JAMES A. FITZPATRICK NUCLEAR POWER PLANT

AMENDMENT TO FACILITY OPERATING LICENSE

Amendment No. 98
License No. DPR-59

ATTACHMENT TO LICENSE AMENDMENT NO. 98

Figure 3.5-1
Thermal Power and Core Flow Limits of
Specifications 3.5.J.1, 3.5.J.2 and 3.5.J.3

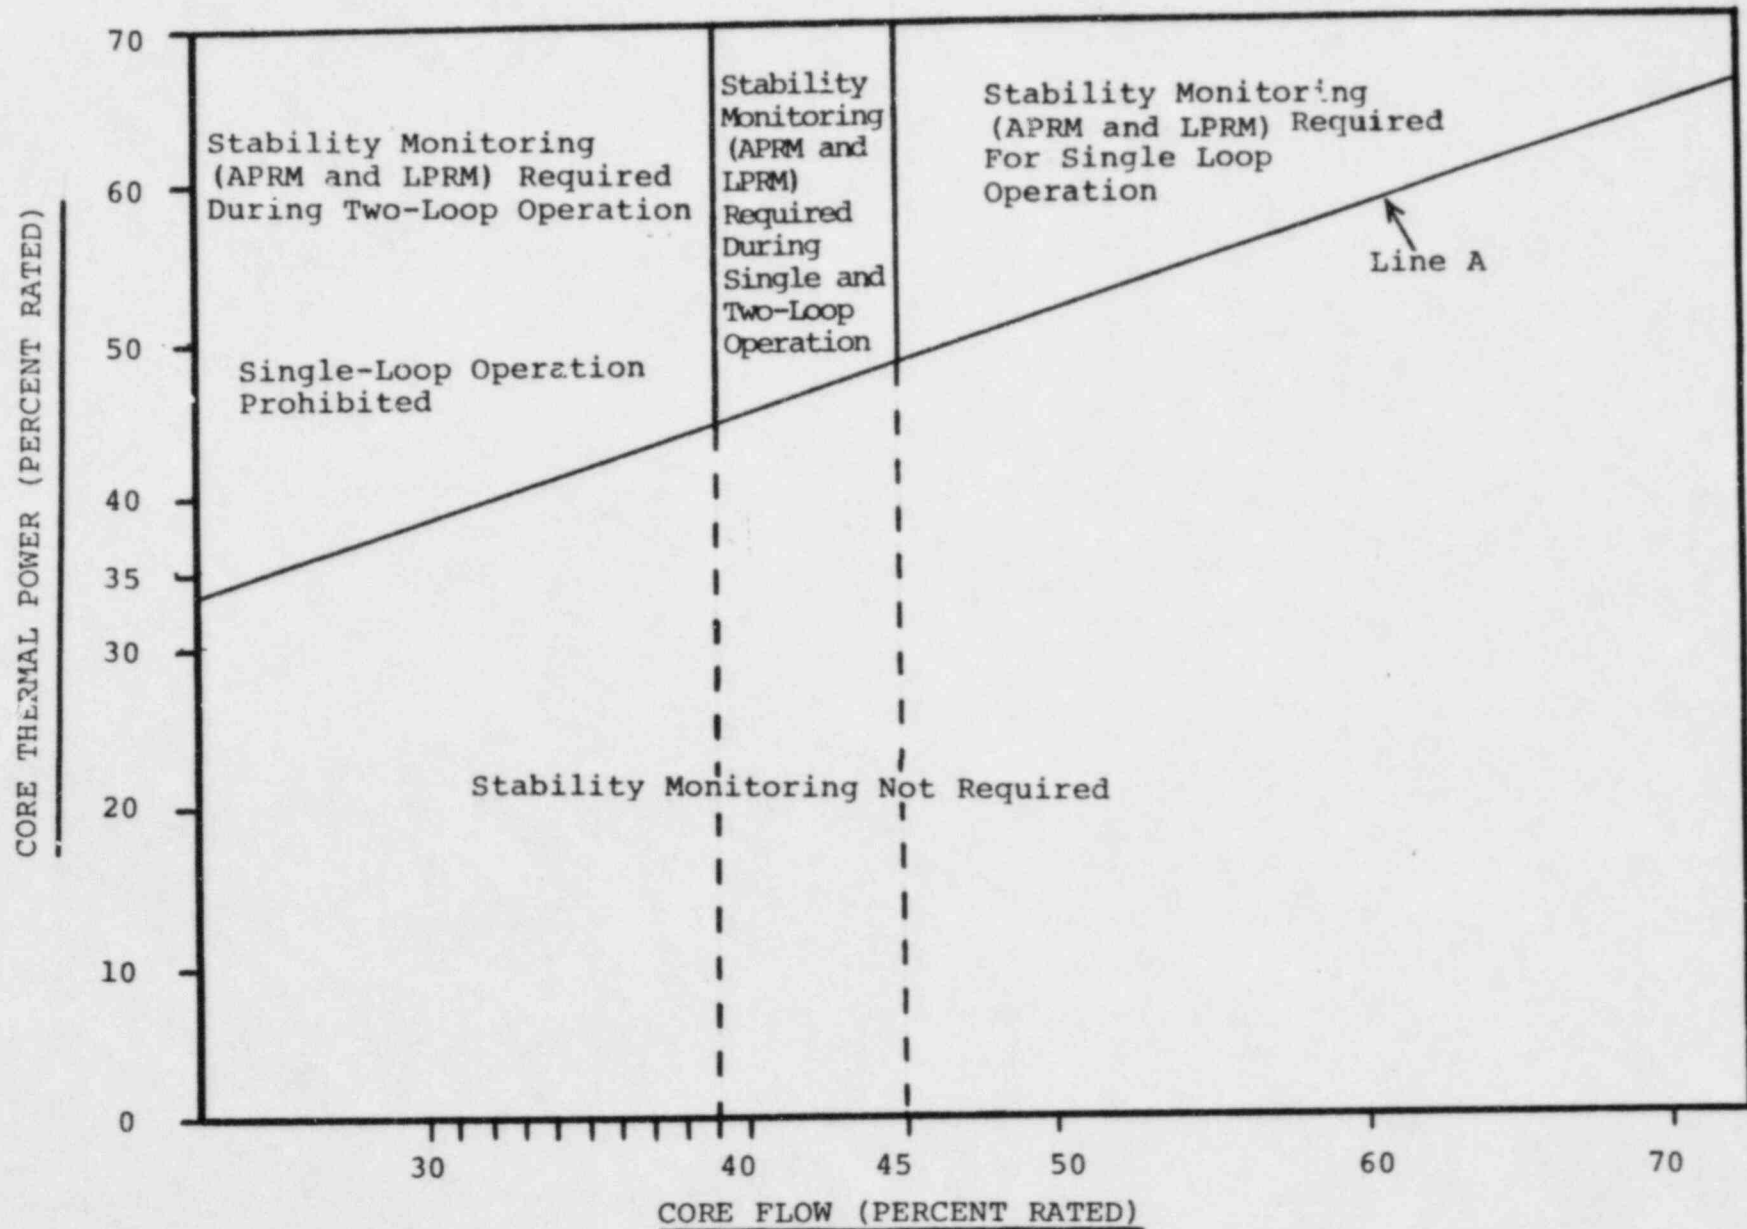
- a. Total core flow greater than or equal to 45 percent of rated, or
- b. Thermal power less than or equal to the limit specified in Figure 3.5-1 (Line A).

2. With two Reactor Coolant System recirculation loops in operation and total core flow less than 45 percent of rated and thermal power greater than the limit specified in Figure 3.5-1 (Line A); or with one Reactor Coolant System loop operating and thermal power greater than the limit specified in Figure 3.5-1 (Line A):

3. If during single-loop operation, core thermal power is greater than the limit defined by line A of Figure 3.5-1, and core flow is less than 39 percent, immediately initiate corrective action to restore core thermal power and/or core flow to within the limits, specified in Figure 3.5-1, by increasing core flow and/or initiating an orderly reduction of core thermal power by inserting control rods.

Operation in certain regions of the power vs. flow curve have been identified as having a high potential for thermal hydraulic instability (Figure 3.5-1). These regions are located in the high power/low flow area of the curve and can be encountered during startup, shutdown, rod sequence exchange or recirculation pump trip. Operation in these regions is associated with higher than normal neutron flux noise levels. Increased awareness of LPRM and APRM signal noise when operating in these regions will identify instability and allow operator action to correct the problem. The neutron flux noise level, thermal power and core flow limits are prescribed in accordance with the recommendations of General Electric Service Information Letter No. 380, Revision 1, "BWR Core Thermal Hydraulic Stability", dated February 10, 1984.

Figure 3.5-9

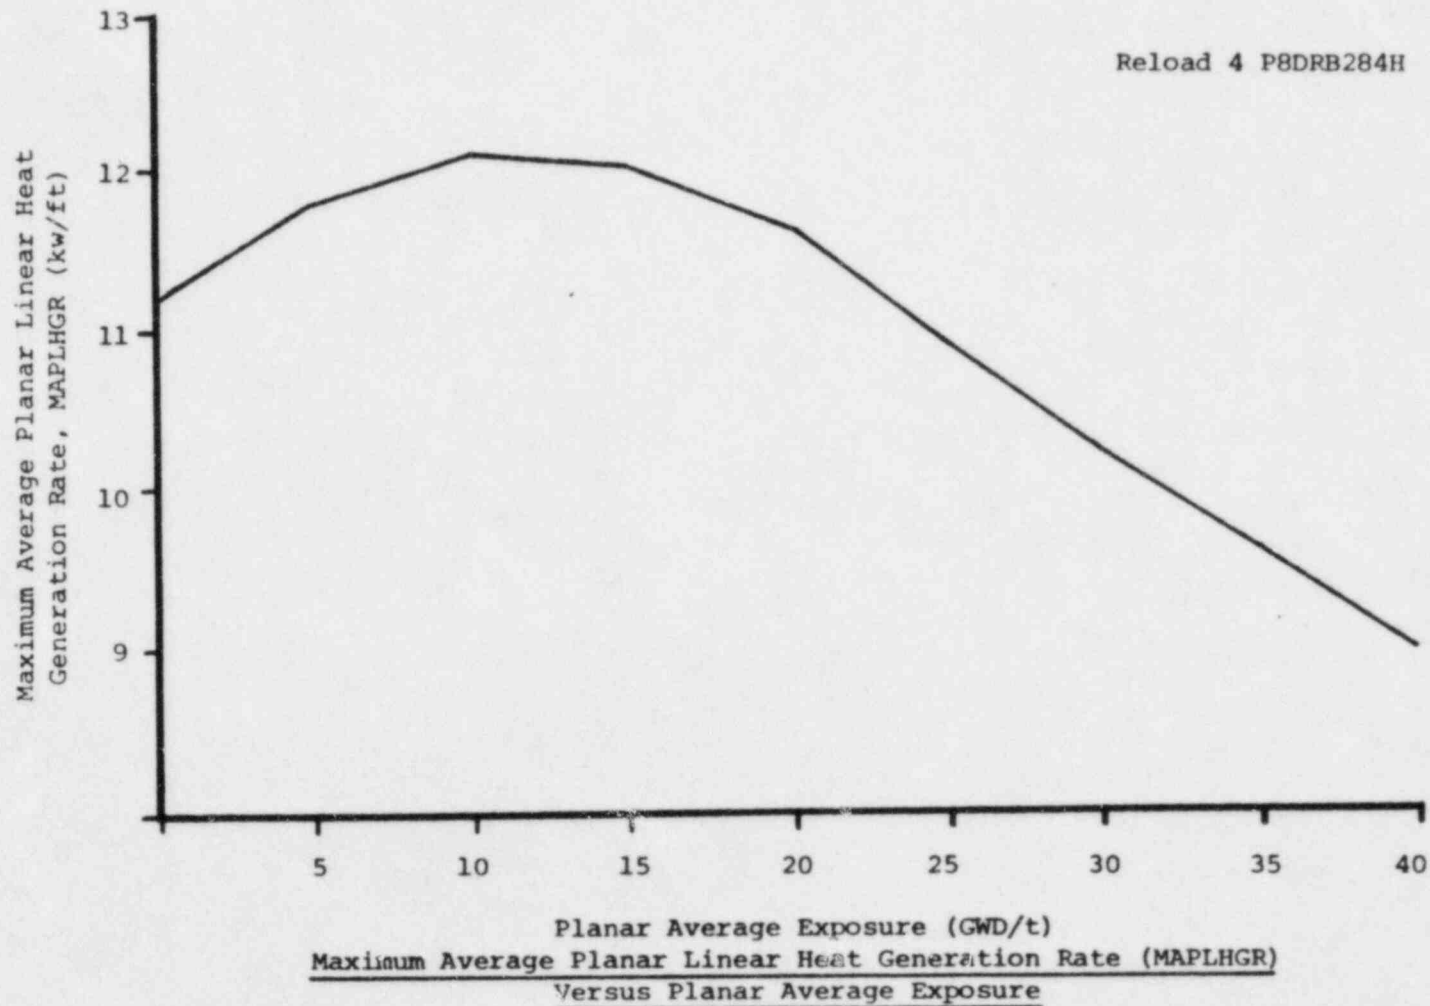
For single-loop operation, these MAPLHGR values are multiplied by 0.84.

Figure 3.5-10

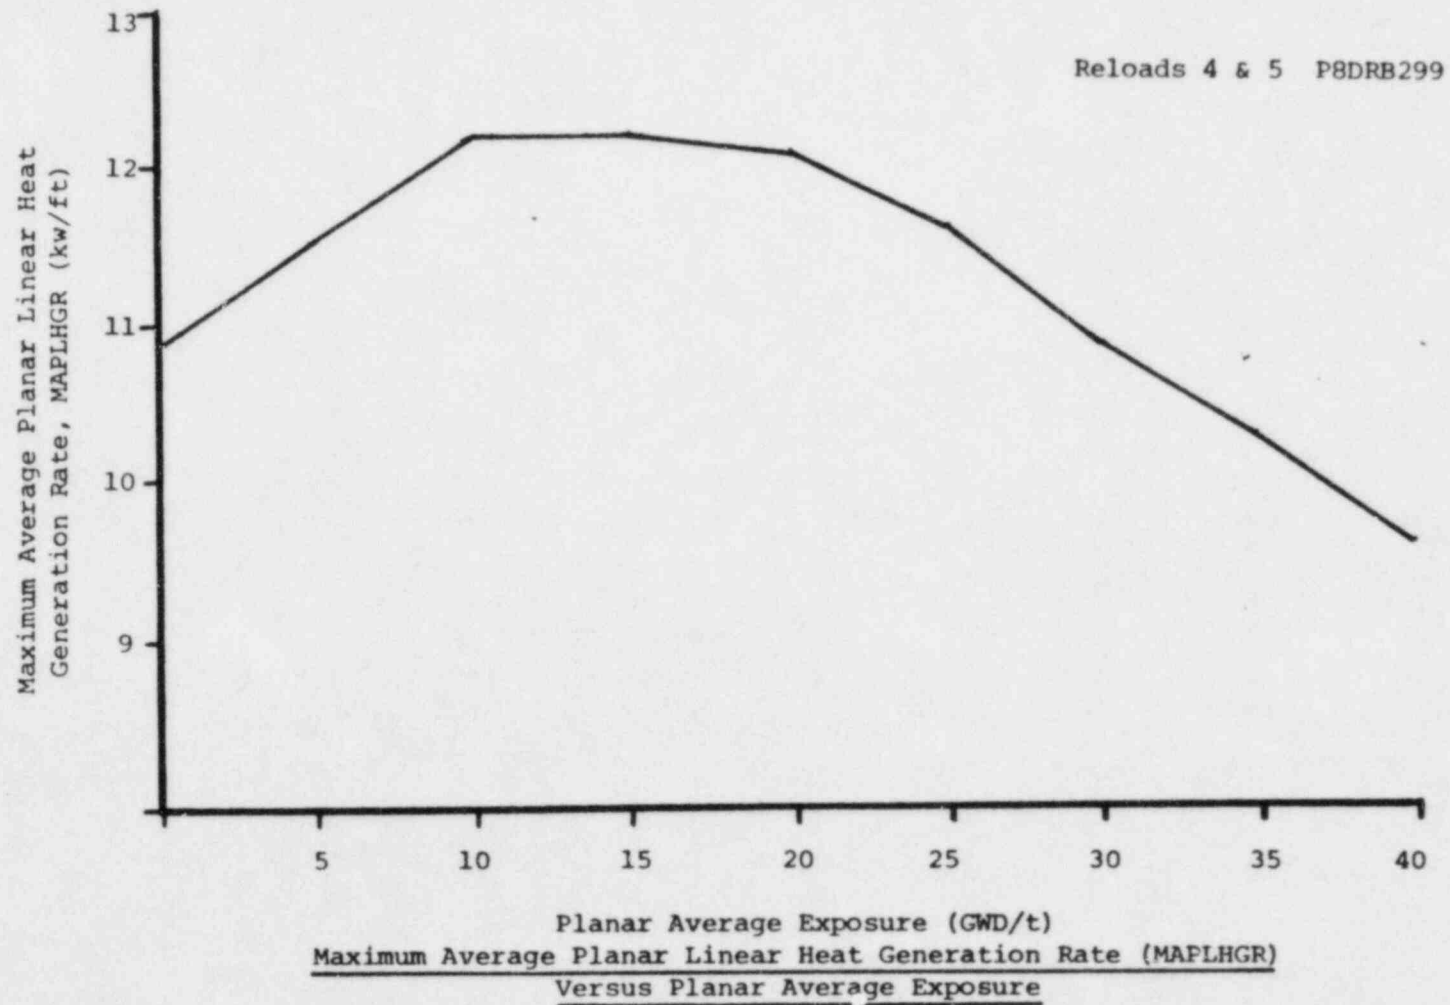
For single-loop operation, these MAPLHGR values are multiplied by 0.84.

Figure 3.5-11

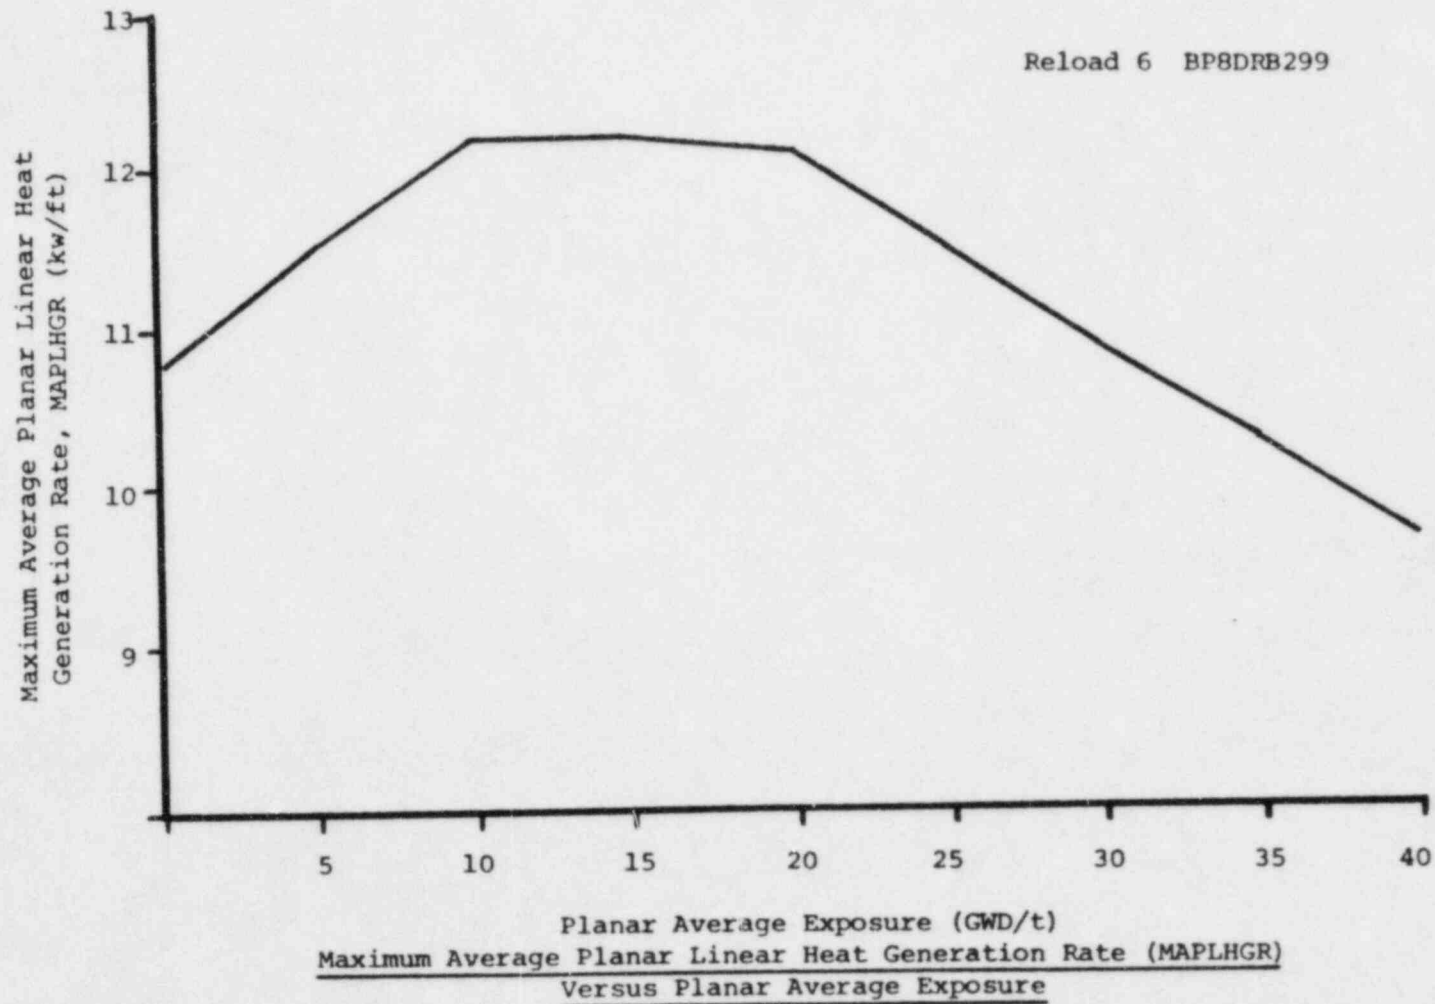
For single-loop operation, these MAPLHGR values are multiplied by 0.84.
